**Proposal for corrigendum to global technical regulation (gtr) No. 2**  
(ECE/TRANS/180/Add.2/Amend.1)

**I. Proposal**

Figure A13-1: Example of a gearshift sketch

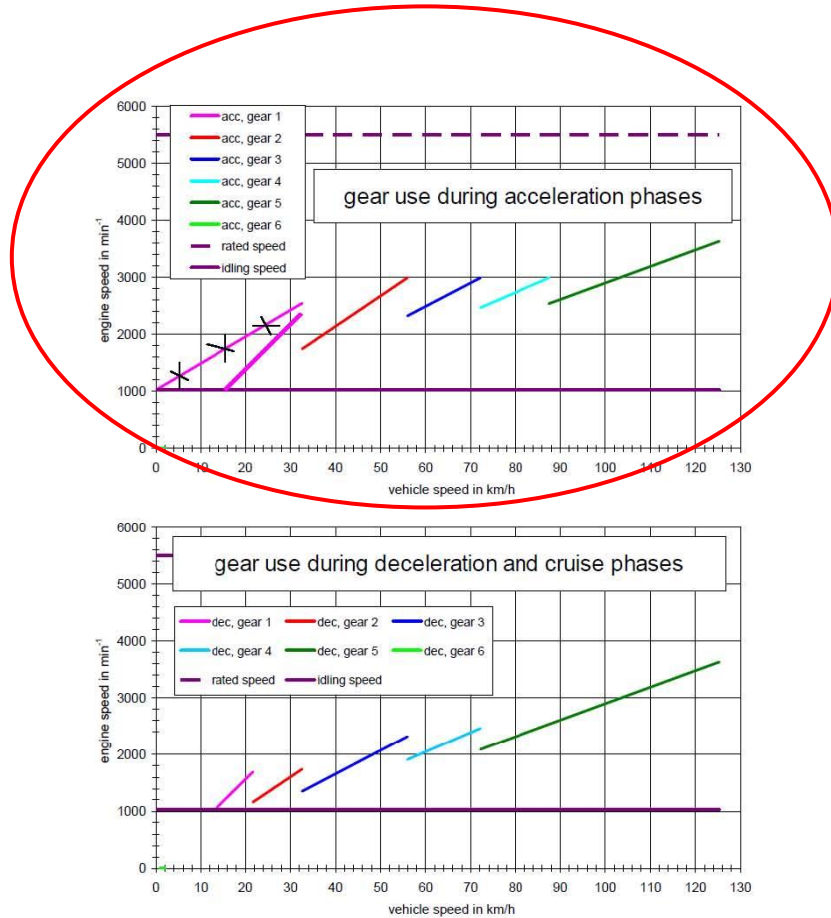
Annex 13, paragraph 1 Figure A13-1, correct the line for “acc.gear 1” in the upper figure for “gear use during acceleration phases” as shown below.

In the upper figure for “gear use during acceleration phases”, the acceleration gear 1 starts from zero, which is not correct.
